Subject: Old Town Escape Barn Assessment Letter; Project No. 658052,  
Internal Order No. 24008534, Old Town

The Development Services Department has completed the Second review of the project referenced above, and described as:

Planned Development Permit and Conditional Use Permit for an escape room with two residences, located at 3886 Ampudia St. The 0.11-acre site is in the OTMCR-1-2 Zone, within the Old Town San Diego Community Plan area.

SHEET TITLE:  
PROPOSED SITE PLAN

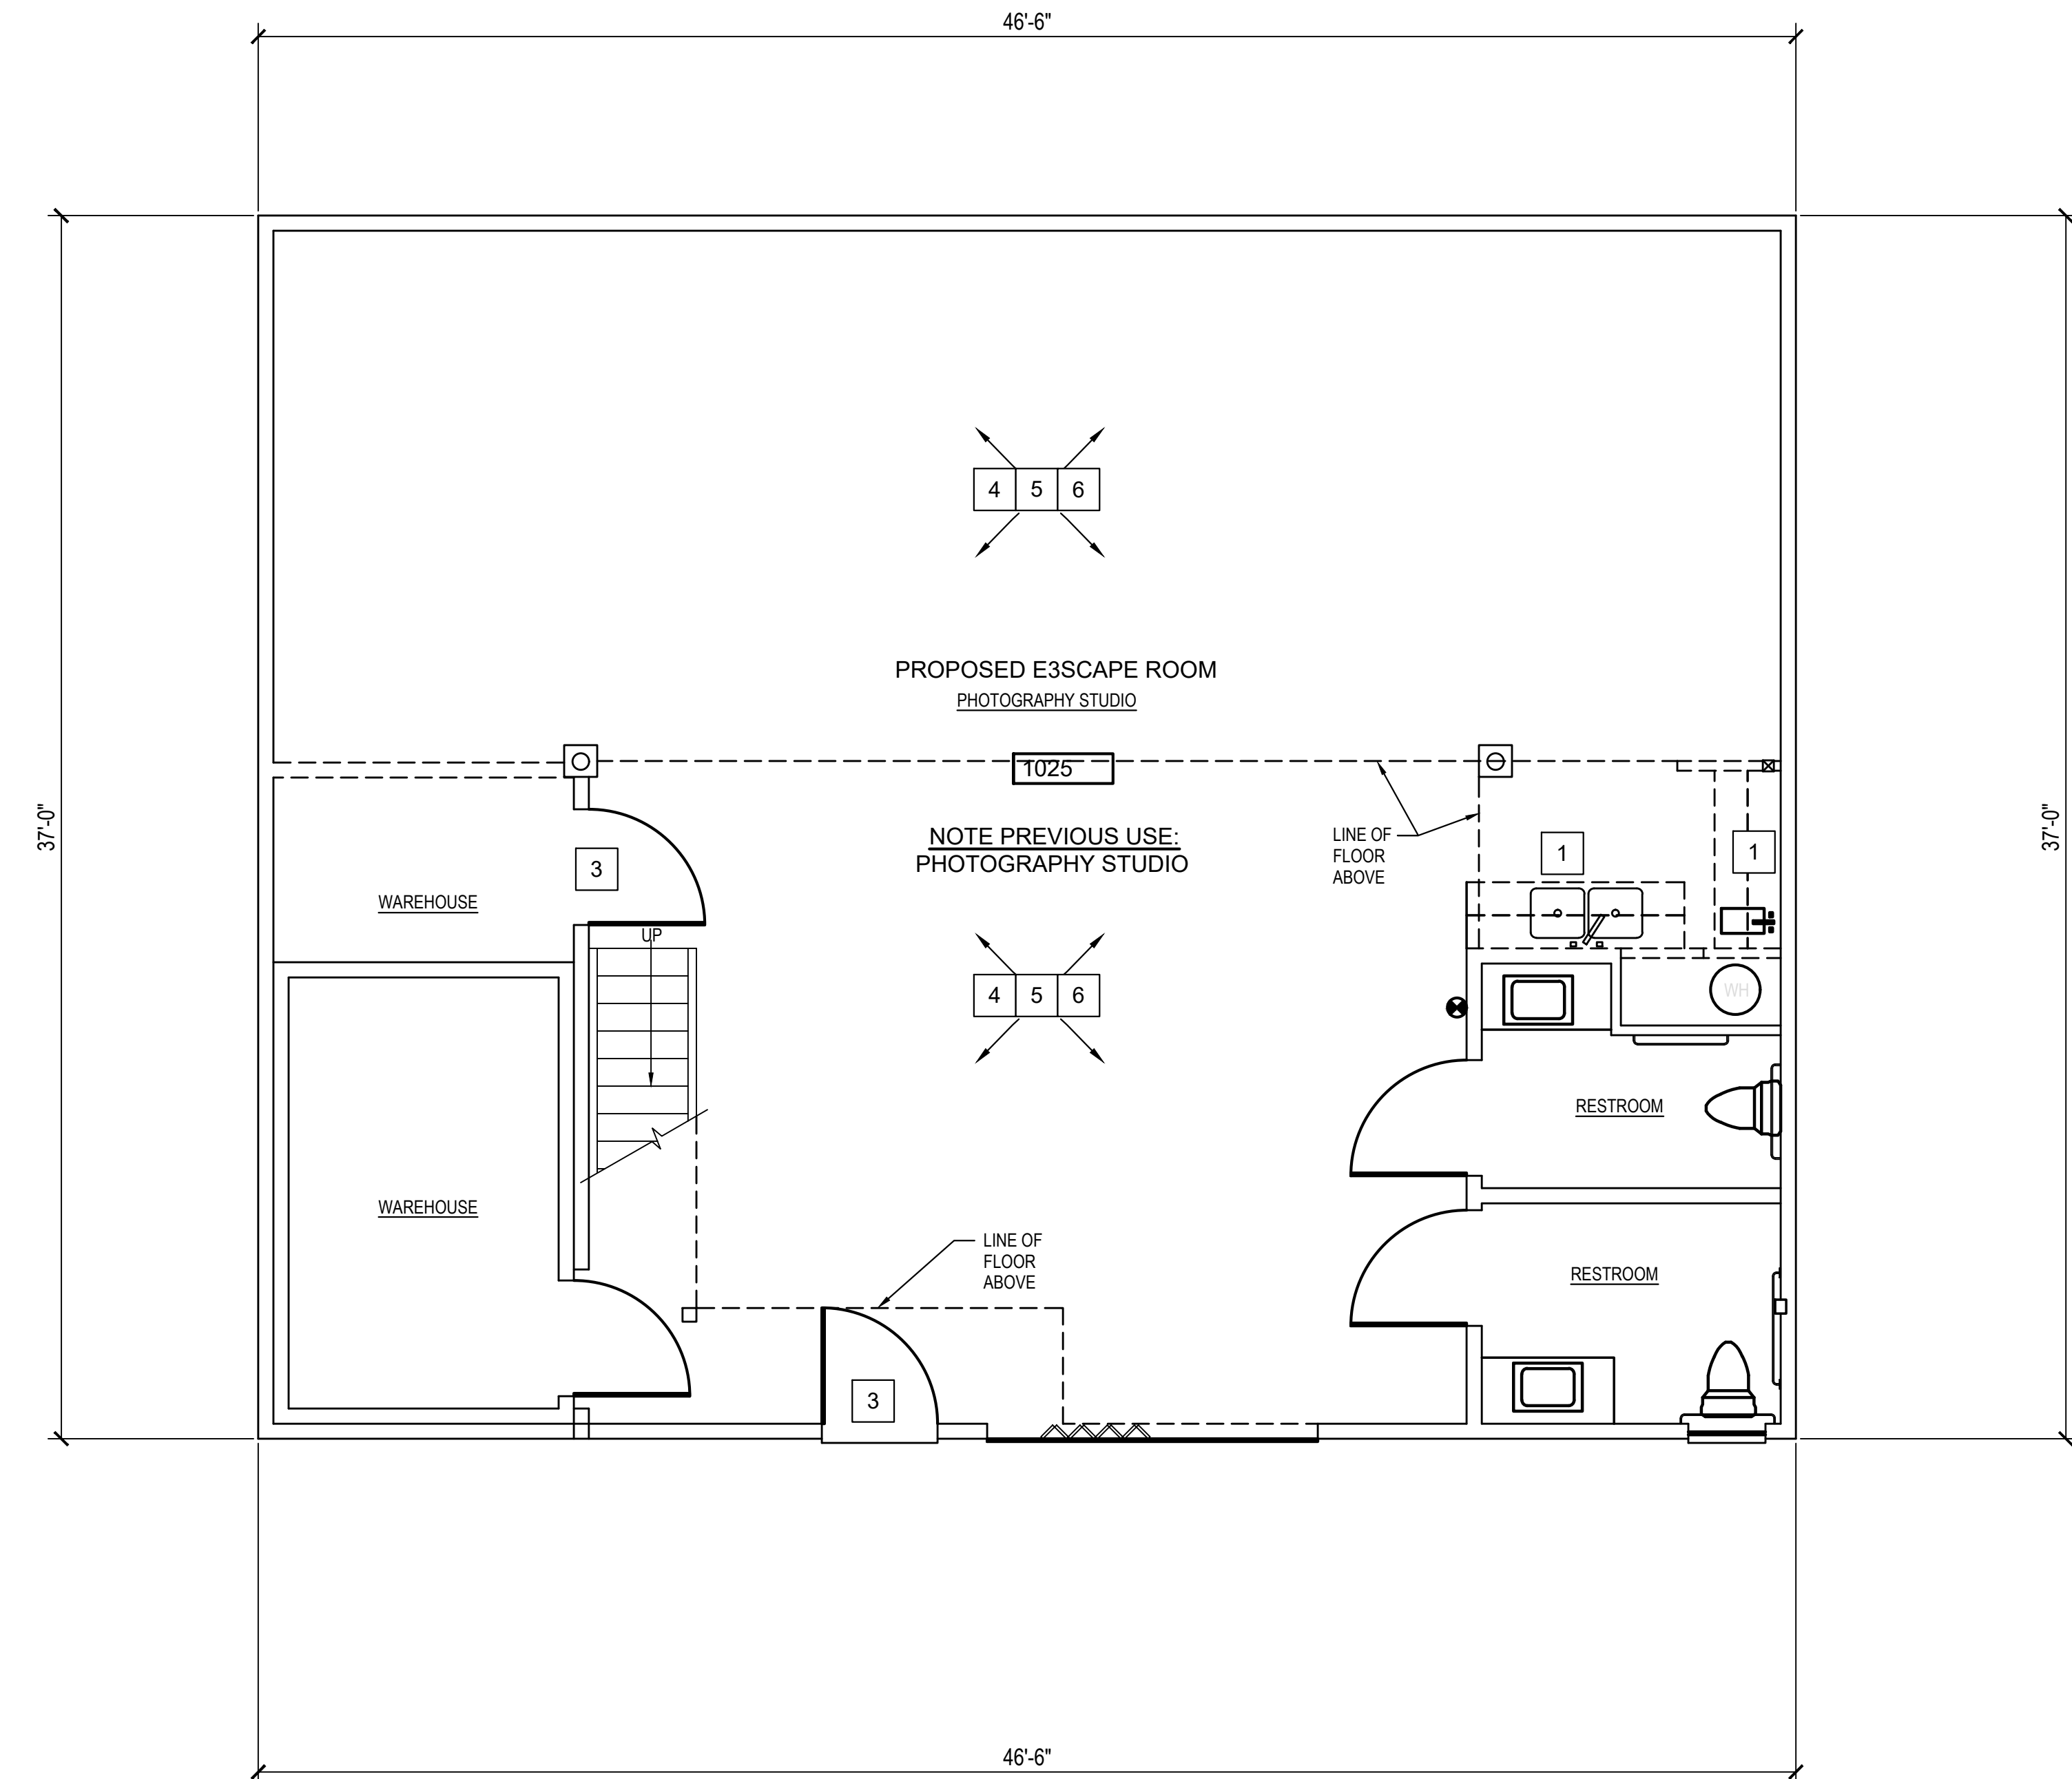
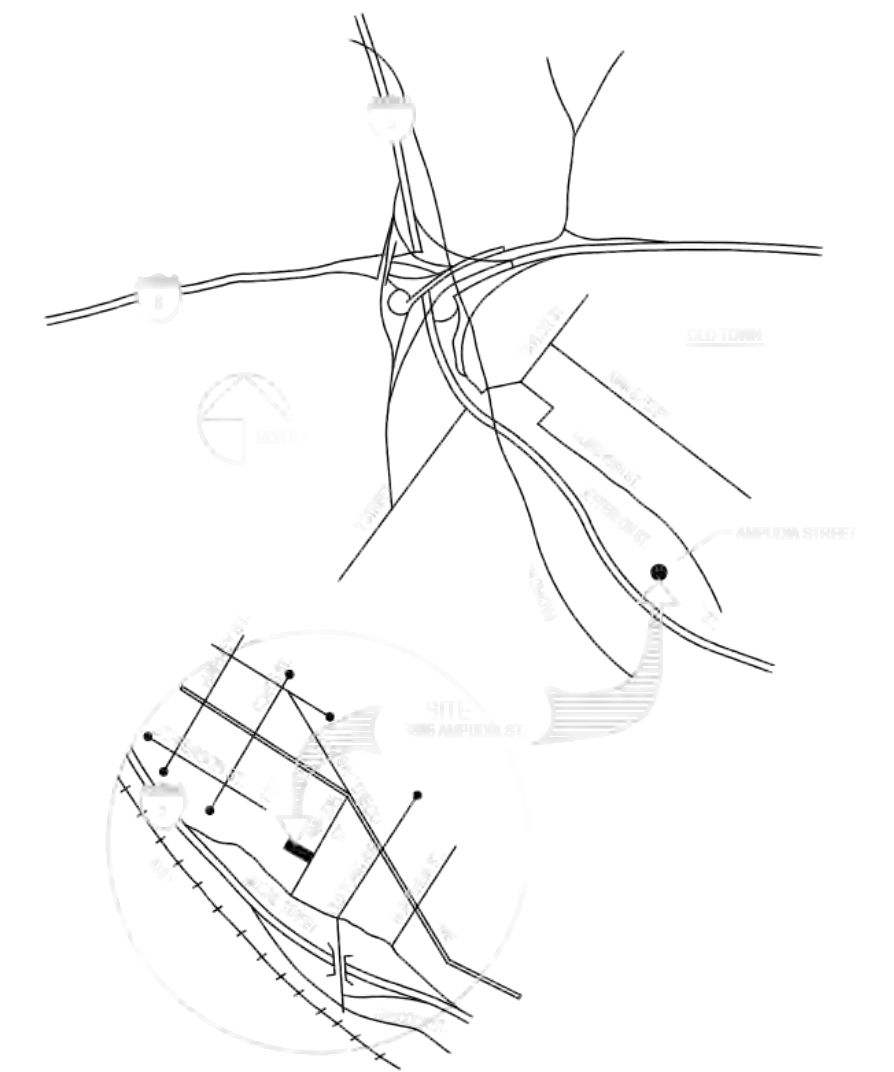
<u>Cleared?</u>	<u>Issue Num</u>	<u>Issue Text</u>
<input type="checkbox"/>	18	Sheet 1, address appears to be incorrect. Sheet 1 shows 3889 Ampudia St. Planning staff believes it should be 3886. Please review and update as necessary. (From Cycle 2)
<input type="checkbox"/>	19	Sheet 1 Summary of Request outlines that scope includes "remodel existing second floor apartment and add an apartment." Sheet 3 existing floor plan/demo outlines two office spaces and no apartment. Please update scope to be accurate. (From Cycle 2)
<input type="checkbox"/>	20	OTMCR-1-2 allows for 1 unit per 800sf of lot area. Please provide a density calculation on Sheet 1. (From Cycle 2)
<input type="checkbox"/>	21	Sheet 1, please provide the maximum FAR permitted per Table 1516-01E. Max FAR is 2.0 with a 0.2 bonus for residential mixed use. Total allowable FAR is 2.2, or 10,696.4sf. (From Cycle 2)
<input type="checkbox"/>	22	Sheet 1, please provide a setback table outlining the required setbacks and the existing setbacks for the building and the proposed setbacks. (From Cycle 2)

<input type="checkbox"/>	24	Sheet 1, please demonstrate compliance to pedestrian paths and walkways as outlined in SDMC 1516.0127(d). (From Cycle 2)
<input type="checkbox"/>	28	Sheet 1, please dimension the curb cut. (From Cycle 2)

<u>Cleared?</u>	<u>Issue Num</u>	<u>Issue Text</u>
<input type="checkbox"/>	55	Follow-up to Issue #18: Address is still inconsistent. On Sheet 1 within Project Development Summary Table #2, the address is shown as 3889. The title block (right side of page) shows address as 3886. The address listed within the City's GIS mapping is 3886. (New Issue)
<input type="checkbox"/>	56	Follow-up to Issue #19: It is still unclear where the location of the original apartment unit is on the floor plan. Please show on the floor plan the location of the original apartment. (New Issue)
<input type="checkbox"/>	57	Follow-up to Issue #20: Density calculation is still not provided. (New Issue)
<input type="checkbox"/>	58	Follow-up to Issue #21: The proposed FAR is provided, but not the maximum allowable per the zone (this is shown as "X"). Please revise to include the maximum allowed, as outlined in Issue #21 above. (New Issue)

<input type="checkbox"/>	59	Follow-up to Issue #22: Setback table is not provided. (New Issue)
<input type="checkbox"/>	60	Follow-up to Issue #24: The walkway is not shown on the site plan (Sheet 1), but it is shown on the landscape plan (Sheet 11). Revise the site plan to be consistent. Callout dimension of walkway width and material of pathway. (New Issue)
<input type="checkbox"/>	61	Follow-up to Issue #28: The curbcut width is not indicated. Please call-out the existing and proposed curbcut widths. (New Issue)

<input type="checkbox"/>	9	On the Site Plan, call out to reconstruct the sidewalk, maintaining the existing sidewalk scoring pattern and preserving the contractor's stamp, adjacent to the site on Ampudia Street (From Cycle 2)
<input type="checkbox"/>	11	Please note the project will be conditioned to obtain Encroachment Maintenance and Removal Agreement (EMRA) for proposed private street trees, landscape/irrigation within Ampudia Street public right of way. (From Cycle 2)
<input type="checkbox"/>	12	Development Permit Conditions will be determined on the next submittal when all requested information is provided. (From Cycle 2)
<input type="checkbox"/>	13	Please provide a written response to all comments whether you agree or not and in case of disagreement express your reasoning. (From Cycle 2)
